AMENDMENT NO. 1 MARCH 2025
TO
IS 18215 : 2023 STAINLESS STEEL *NETI* POT — SPECIFICATION

Amendment No. 1 to IS 18215 : 2023

FIG. 2 COMPRESSION JIG

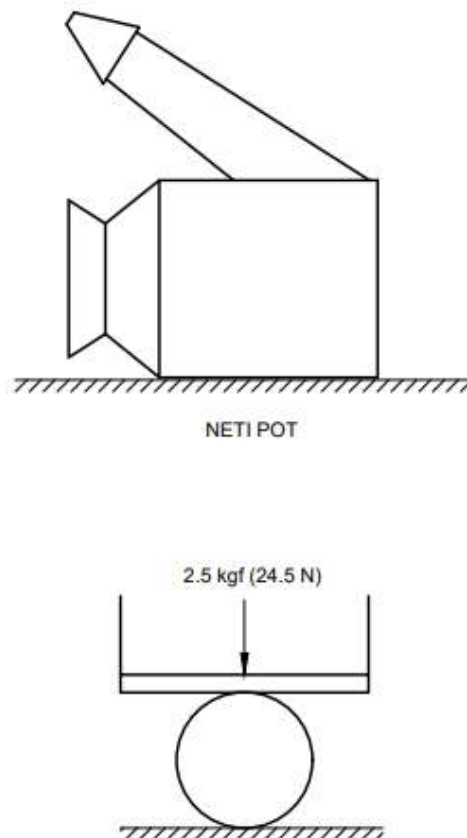
‘ANNEX A

(Clause 8.4)

COMPRESSIVE LOAD TEST

A-1 PROCEDURE

Place the sample specimen of the stainless steel *Neti* Pot in horizontal condition on the platform given in the compression testing equipment as shown in Fig. 2. Apply the compressive load in the middle part of the body or to the part having the maximum diameter of a stainless steel *Neti* Pot by the use of compressive jig. Gradually increase the top load and apply on the top horizontal surface of the pot by maintaining a speed of the machine at the rate of 10 mm/min for a period of 1 min, up to the maximum load of 2.5 kgf, to assess the withstanding capacity of the steel pot without any deformation.

A-2 ACCEPTANCE CRITERIA

There shall not be any dent or deformation on the body of the steel bottle after applying the load of 2.5 kgf.’
